**From:** Kuntz, Robert  
**Sent:** Monday, September 08, 2014 3:10 PM  
**To:** RILEY, Jim (jhr@nei.org)  
**Cc:** Whaley, Sheena; Cook, Christopher  
**Subject:** NRC Comments on NEI white paper regarding warning time for LIP event  
**Attachments:** Warning Time for Extreme Precipitation Events (NWS Protocol) Rev2 9-8-14 with NRC comments.pdf

# Warning Time for Maximum Precipitation Events

Rev 1a, 8-14-14

### Probabilistic Quantitative Precipitation Forecasts (PQPFs) – EXAMPLE

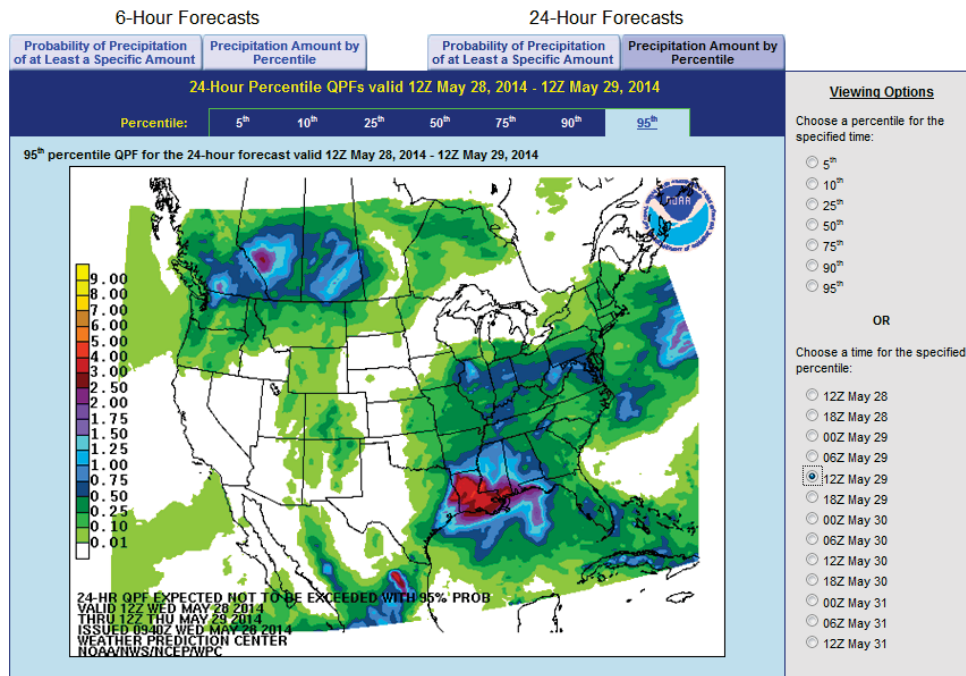
**Comment [NRC28]: Editorial/technical note:**  
The actual map image in Attachment 1 only shows information in the second form (precipitation amount by percentile). However, it does show the tool with tabs for the different types.
